# Digi-Star Product Bulletin

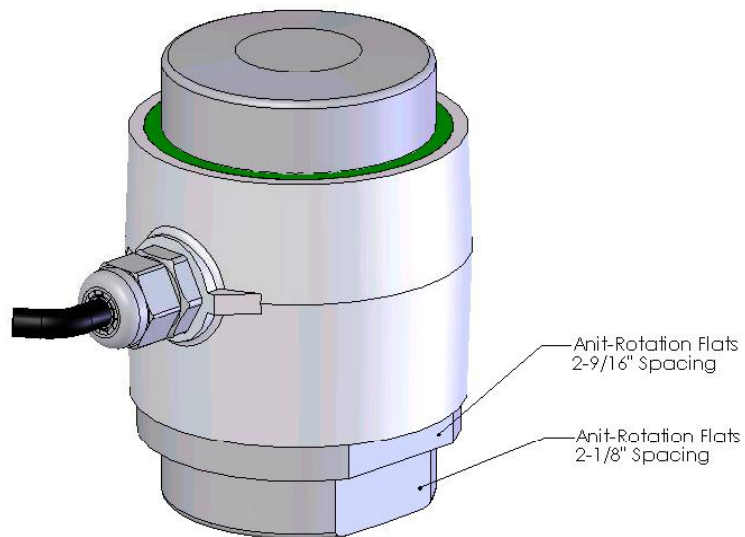
In order for Digi-Star to meet the needs of all customers, 30K and 50K CT's will be modified to include additional anti-rotation flats. These flats, located on the lower 2.437 diameter base and spaced at 2.125", will allow greater flexibility for the OEM while maintaining the load cells weighing performance.

As the additional anti-rotation flats will have no adverse effect on form, fit, or function, they will be added as a running change in the near future. The change will be made first on 30K CT's then on 50K CT's. Once the transition occurs, the change will be permanent.
